Response to Request for Additional Information
Generic Letter 2004-02

Surry Power Station Units 1 and 2

VIRGINIA ELECTRIC AND POWER COMPANY
(DOMINION)

Figure 1 - Test Parameters vs. Time for SPS RS Strainer Test

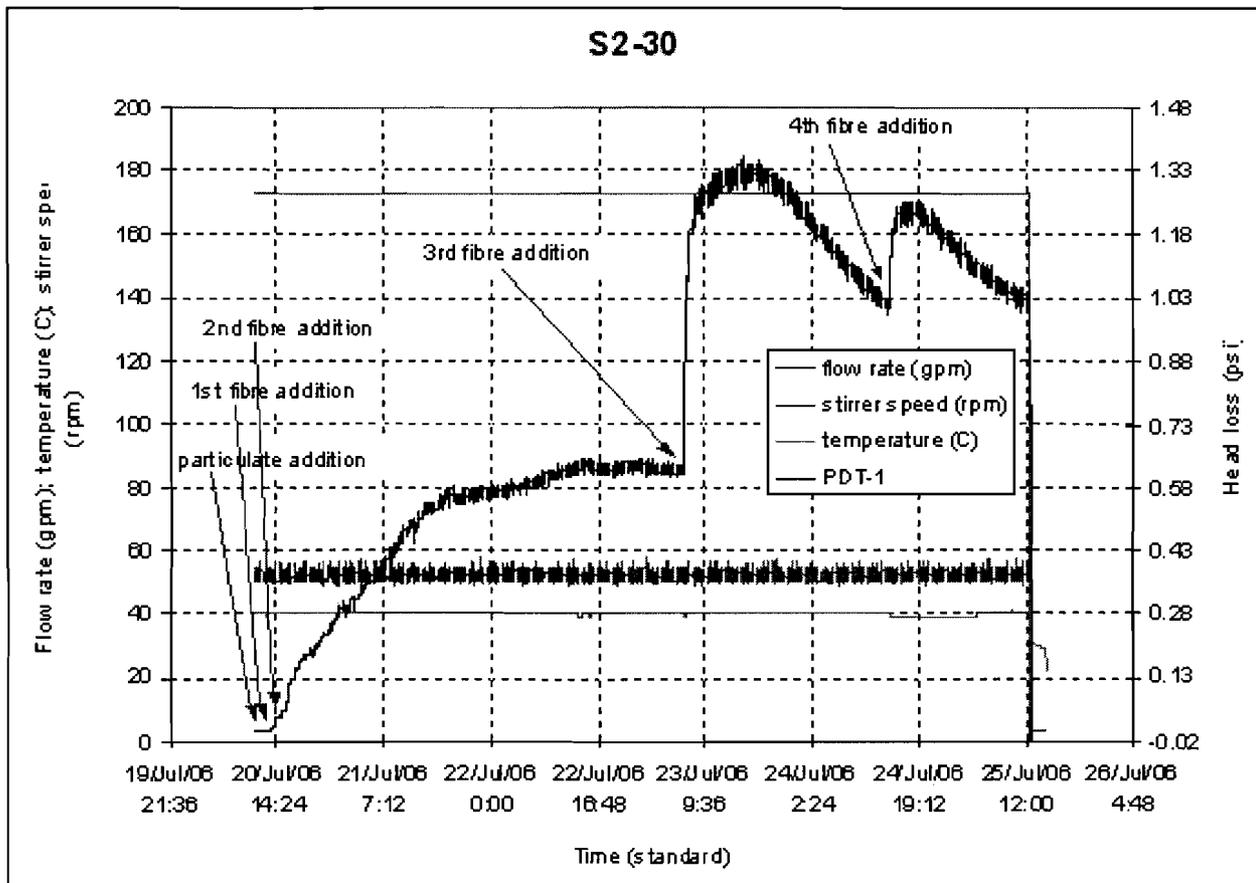
Please provide additional information that justifies the temperature/viscosity extrapolation of data from test temperatures to predicted loss-of-coolant accident (LOCA) temperatures. Based on recent review of Rig 33 head loss traces for North Anna during the chemical effects audit of that plant, the staff believes that there may not have been "sudden" decreases in measured head loss, but there were anomalous observations of fairly large and relatively fast head loss decreases for qualification tests and other non-qualification tests for North Anna. Flow sweeps were done for some of the tests that seemed to indicate that boreholes did not have a significant influence on the temperature scaling. However, the staff does not consider this information sufficient to conclude that there were no signs of potential bed degradation. Please provide results of evaluation of the cause of the decreases in head loss that occurred during testing.

As shown in Figure 1, the peak RS head loss occurred after the third fiber addition. After that, the head loss was in a slowly decreasing trend for a full day, with no sudden head loss decrease. The fourth fiber addition increased the head loss to 1.2 psi. Again, about 4 hours after the fourth fiber addition, the head loss decreased slowly again. The decreasing trends after the third and the fourth fiber additions were almost parallel, which indicated that the debris bed structure was consistent after the fourth addition.

Figure 5 - Head Loss vs. Time during SPS LHSI Chemical Effects Test

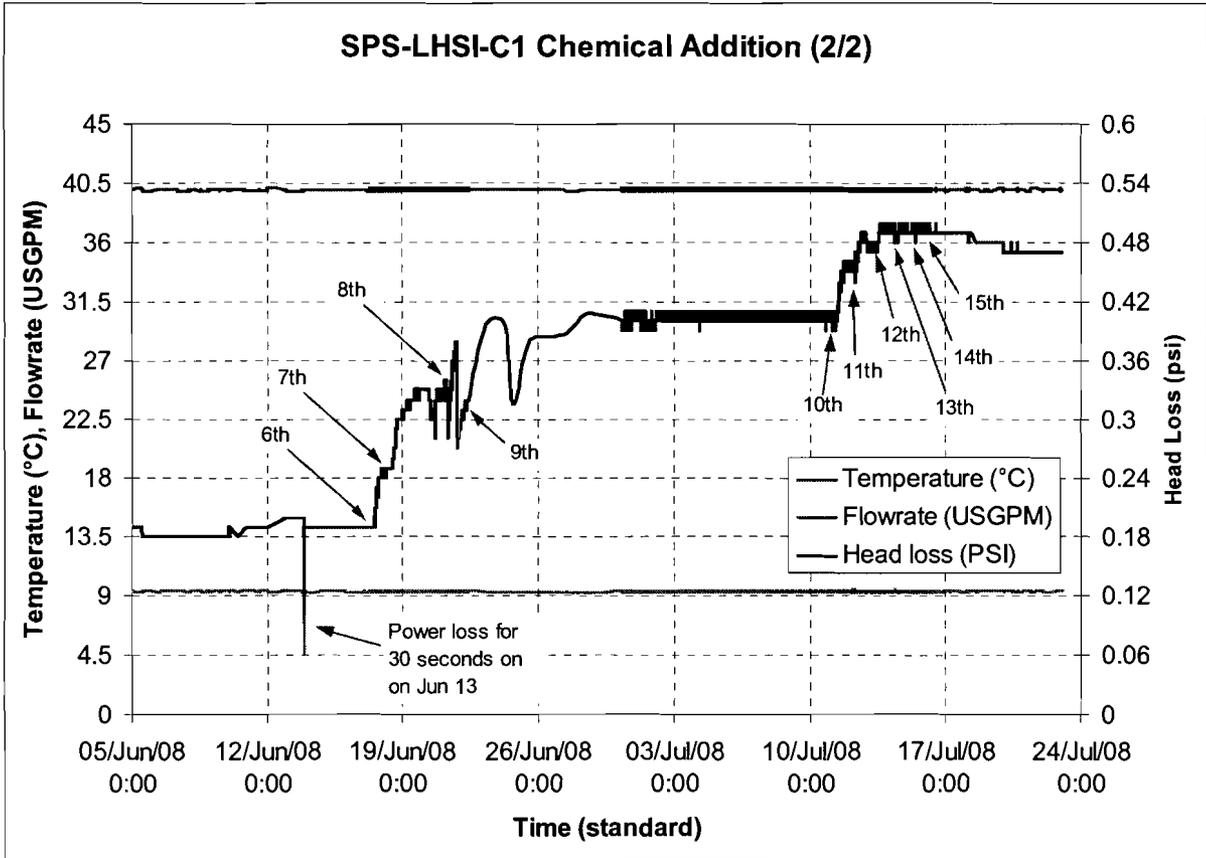
Please provide an evaluation of the head loss fluctuations that occurred during the low-head safety injection (LHSI) Rig 89 testing between the 7th and 10th aluminum additions. Also, please explain why these fluctuations do not invalidate any viscosity corrections imposed on the test data.

The head loss fluctuation between the 7th and the 10th aluminum additions during the Surry LHSI chemical effects testing is shown in Figure 5. As observed in the chemical effects tests, aluminum precipitate tended to deposit on the fiber surface and block the pores of the debris bed. At the time the 7th aluminum addition was added, the head loss was only 0.24 psi. Since the head loss was low, the debris bed was not tightly compact and it was fragile. As more aluminum precipitates deposited on the fiber surface, a dynamic process of debris bed cracking and self-repairing was initiated, which resulted in the head loss fluctuation. As more aluminum was added to the test tank, the head loss became higher and the debris bed was more densely compact and there was no fluctuation between the 11th and the 15th additions.

The peak measured head loss in the Surry LHSI strainer chemical effects test is 0.5 psi at 104°F, which occurred after the 15th aluminum addition. The long-term acceptance criterion for debris bed plus chemical effects (after subtracting allowance for analytically determined clean strainer head loss) is 1.41 feet of water at 104°F, which is equivalent to 0.61 psi at 104°F. Since the test temperature and the long-term sump temperature is the same, viscosity correction is not performed.
